RE: **13424 Cedarbrook Ave NE**
Request for Pad Certification – Accepted
Grading Plan Stamp Date: 11/27/18
Certification Dated: 12/3/18
Drainage File: F23D013

Based on the submittal received on 12/11/18, the Engineer's Certification is approved for Building Permit.

ENGINEER'S SEAL 11/27/18 DAVID SOULE P.E. #14522	13424 CEDARBROOK AVE.	DRAWN BY DEM
	GRADING AND DRAINAGE PLAN	DATE 9-23-2018
	 Rio Grande Engineering 1800 CENTRAL AVENUE SUITE 301 ALBUQUERQUE, NM 87108 (505) 872-0000	SHEET # 1 OF 1
		JOB # XXXXX

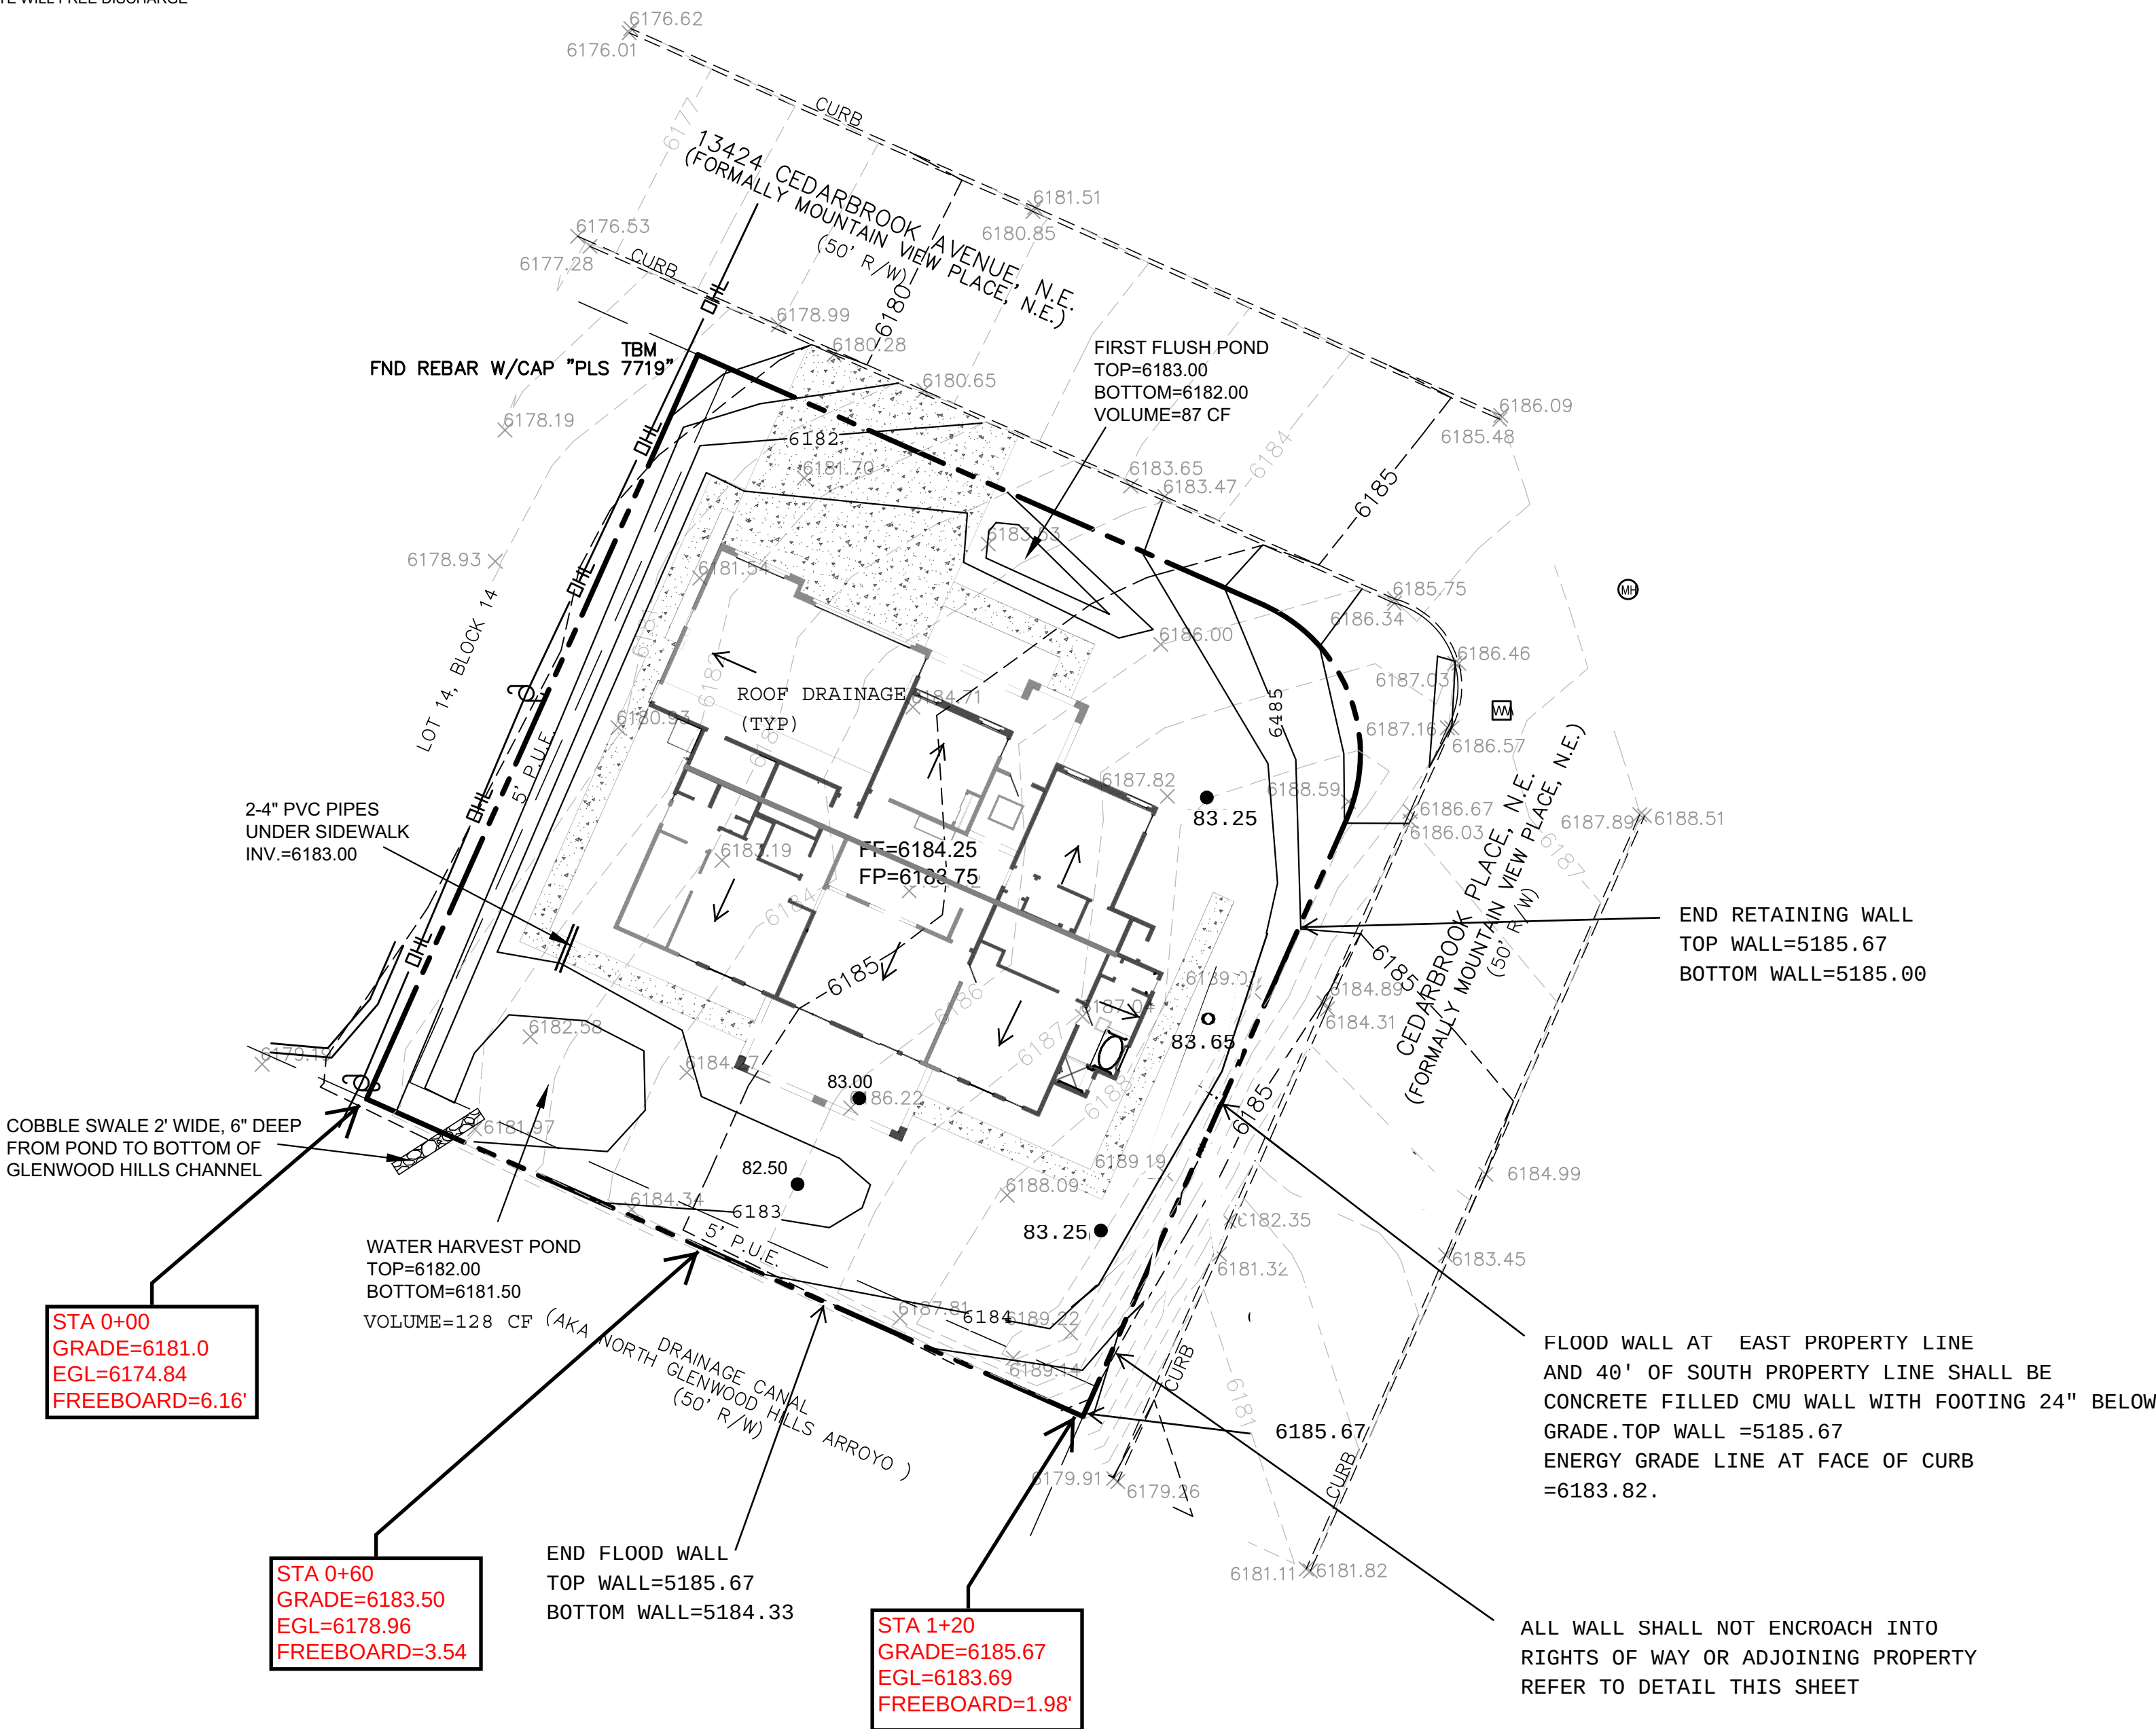
1. Engineer's Certification, per the DPM Chapter 22.7: *Engineer's Certification Checklist For Non-Subdivision* is required to ensure the site and the grades along the property lines were not disturbed during home construction.
